## 1 Products affected

## 2 Type of change

Product Change Notification					PCN KEA		
owner	creation date	release date	released by	change order no	rev	page	D10-016-591
bachmajo	03.07.2017	13.09.2017	buerglal	2013177	A	1 of 2

Old label with old configuration code	New label with new configuration code

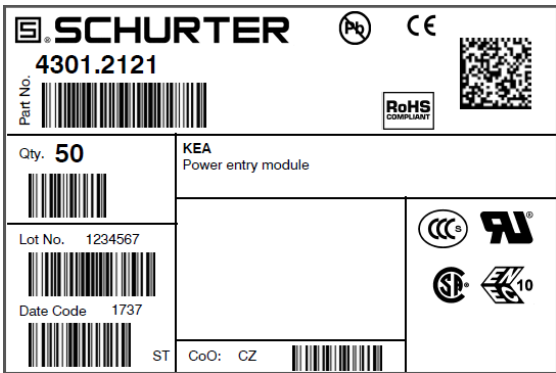
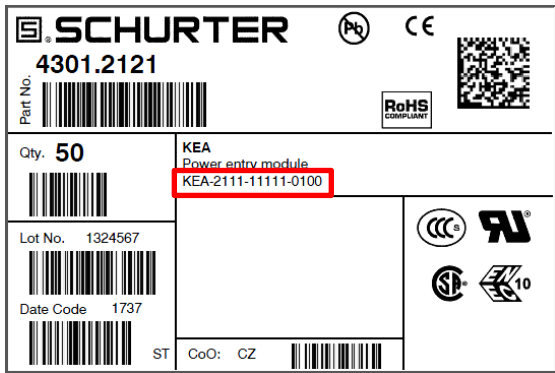
Change of plastic material from PET to PA6 (Socket)  
Inclusion of configuration code on label
